ORIGINATION FORM

Proposed Revisions to a Standard Plans Index

Index Number: 430-012

Index Title: U-Type Concrete Endwall

SHEET
1 of 3

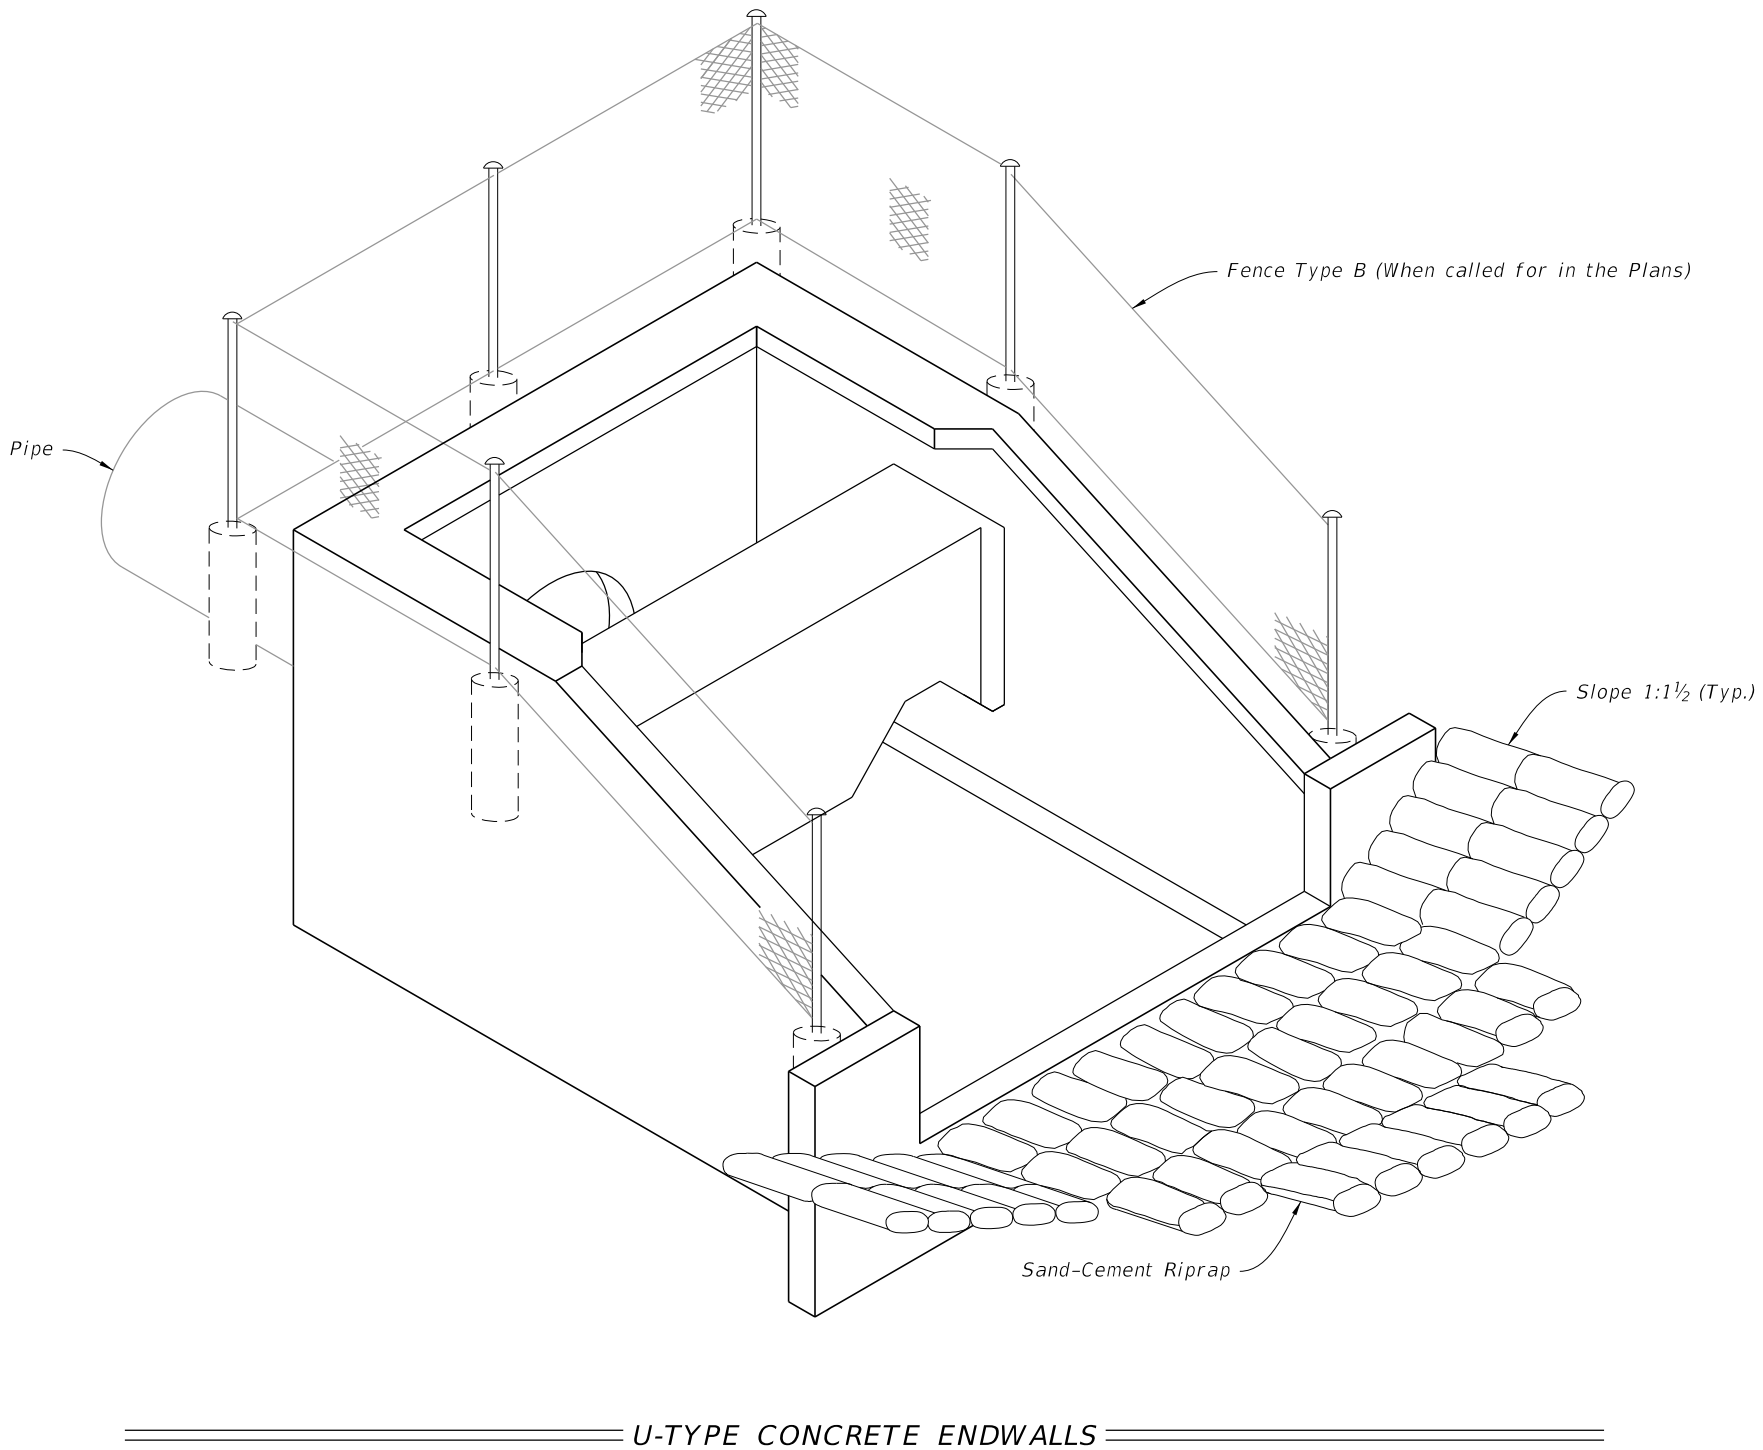
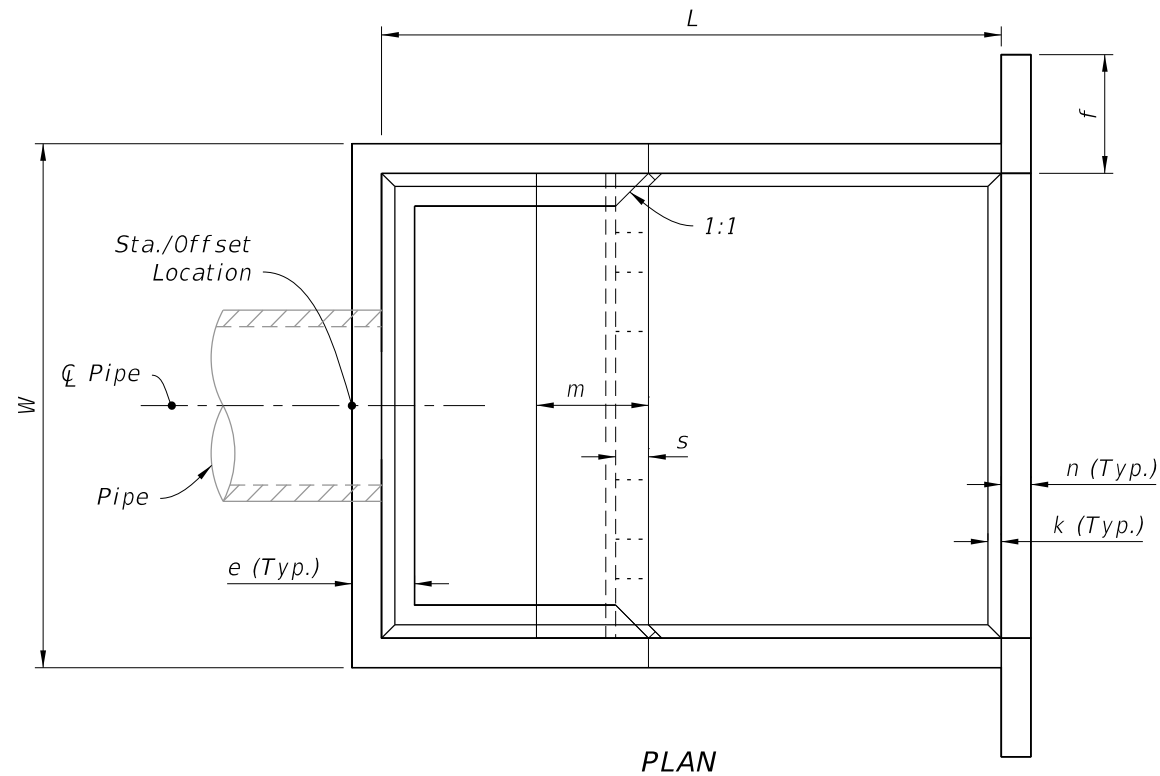
Sheet 1: Added GENERAL NOTE 5 "Install Type D-2 geotextile in accordance with Specifications 514."

Note 5 - Install Type D-2 geotextile in accordance with Specification 514.

LAST REVISION	DESCRIPTION:	FDOT	FY 2023-24 STANDARD PLANS	U-TYPE CONCRETE ENDWALLS ENERGY DISSIPATOR 30" TO 72" PIPE	INDEX 430-012	SHEET 2 of 3
11/01/19	11/01/23

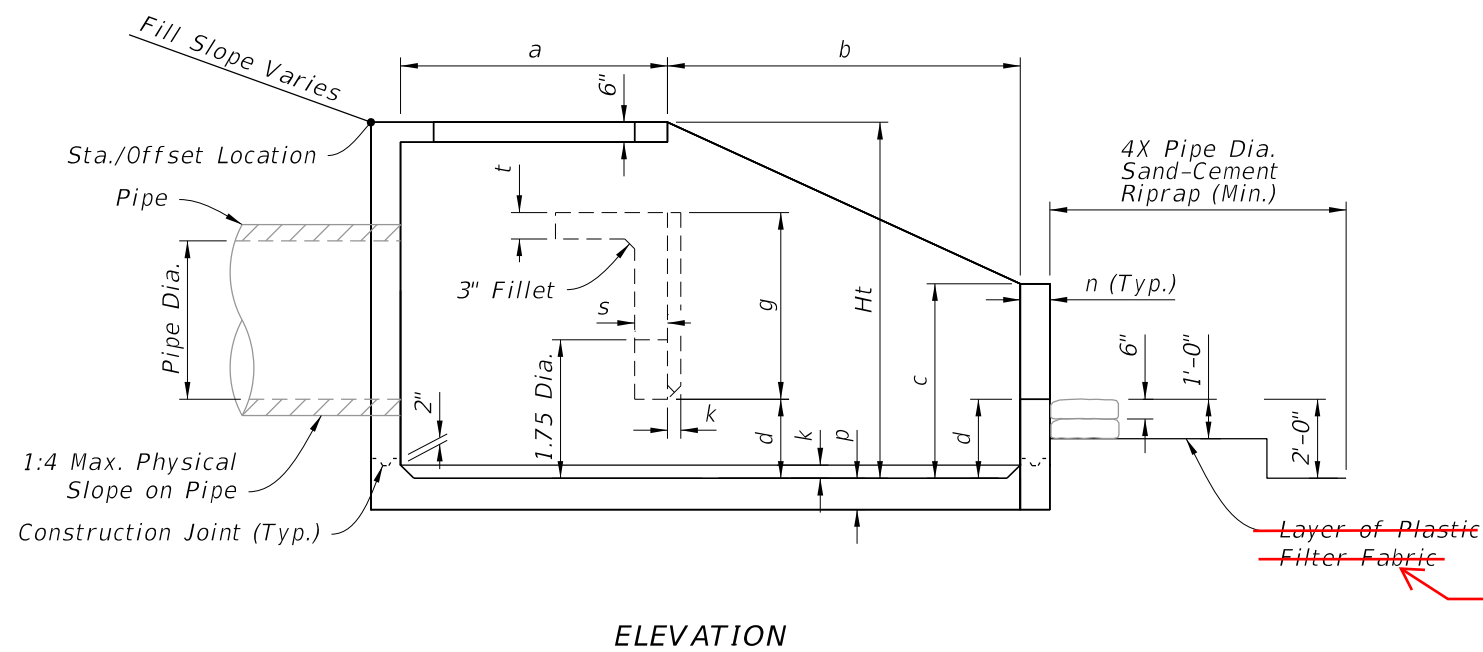
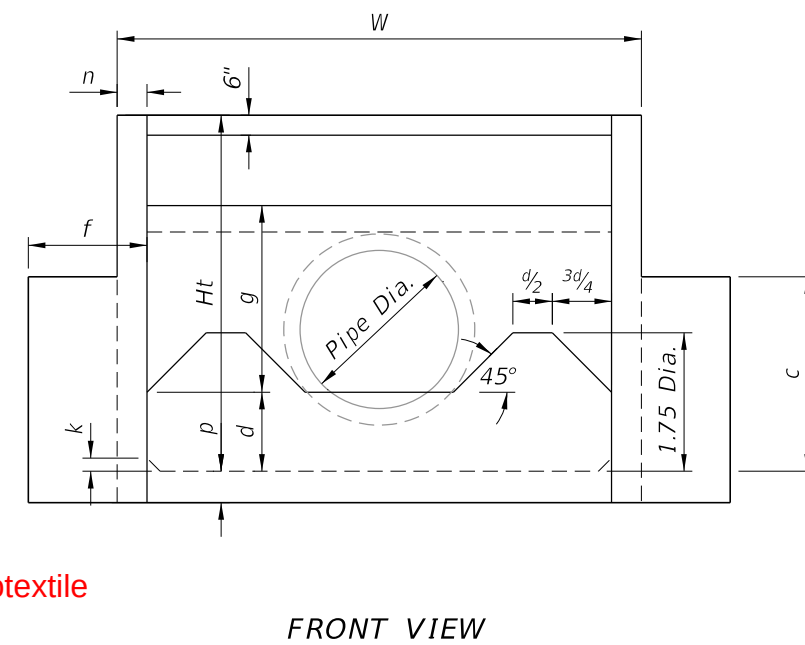
Sheet 2: Changed all references of "Filter Fabric" to "Geotextile".
